# Supplementary report to Sydney Central City Planning Panel

Panel reference: 2016SYW077

<b>DA number</b>	JRPP-16-03306	<b>Date of lodgement</b>	31 March 2016
<b>Applicant</b>	Brooks Projects Architects		
<b>Owner</b>	Li and Qing Unit Trust		
<b>Proposed development</b>	Construction of a part 3 storey and part 4 storey residential flat building, containing 106 apartments, 2 levels of basement car parking and associated landscaping and stormwater drainage works		
<b>Street address</b>	210 Grange Avenue, Marsden Park (proposed Lot 7 approved by DA-15-02309, currently Lot 9 DP 802880)		
<b>Notification period</b>	26 April to 10 May 2016	<b>Number of submissions</b>	1

- 3.1 The Applicant has submitted revised Plans – Architectural Drawing BPA1507skA4m and Revised Landscape Plans A-L01-E, A-L02-D, and A-L03-B (at attachment 1).
- 3.2 The landscape and architectural plans are now consistent. The additional details provided on the landscape plans sufficiently provide the additional requested communal open space features, treatment and quality for future occupants of the development.
- 3.3 In terms of the central communal open space, the revised Landscape Plan Issue D (see Figure 1) has

Figure 1 Revised Central Communal Open Space - Landscape Plan L02-D (excerpt)

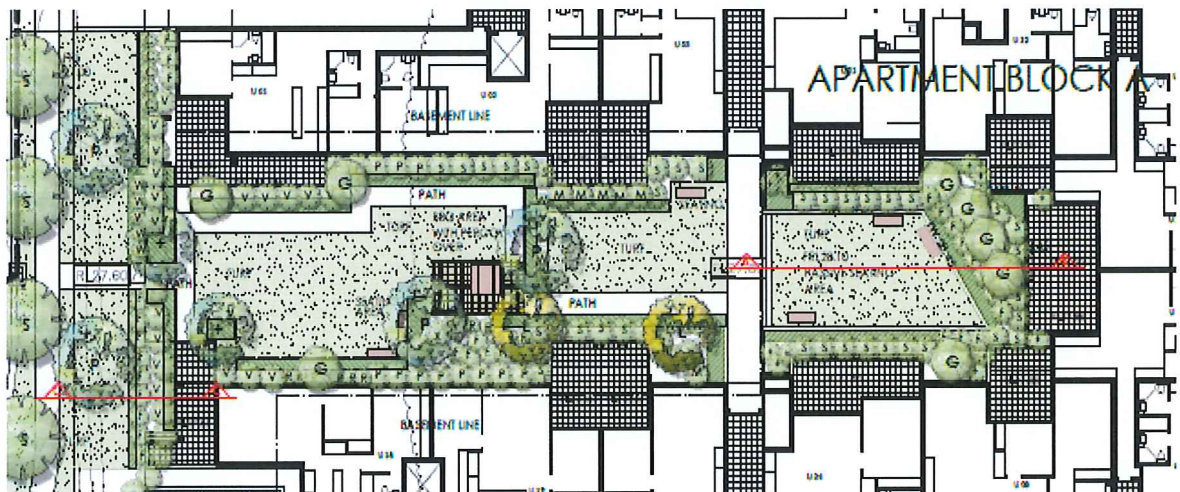
- *There is no detail provided as to whether shading is to be provided over any of the deck areas;*
  - *The amount of decked area to central COS is to be reduced and details provided as to how this space relates to the private terraces immediately adjoining them;*

Figure 2 Revised Western Communal Open Space – Landscape Plan L02-D (excerpt)

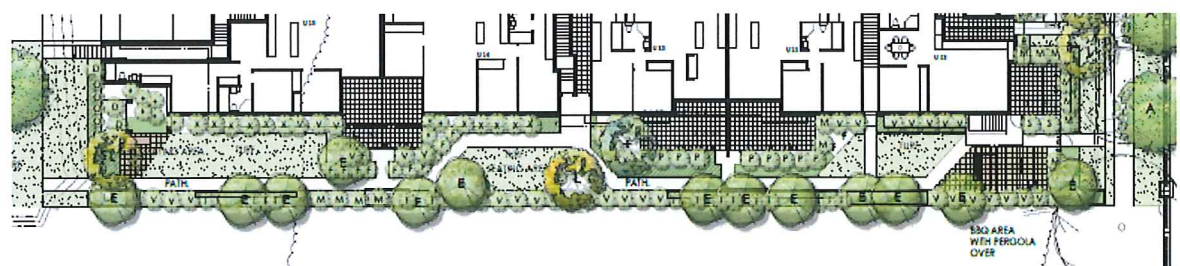
- *Resolution of the western open space is required to make it more inviting, with seating options and useable space for residents; and*

- 3.4 Within the western located communal open space (see Figure 2) the pedestrian path now meanders along the western boundary with realignment of tree planting to assist softening the pathway within this space. The pathway also extends to Grange Avenue where it previously terminated at the building elevation. Additional BBQ facilities and seating is now provided with shade structures over.
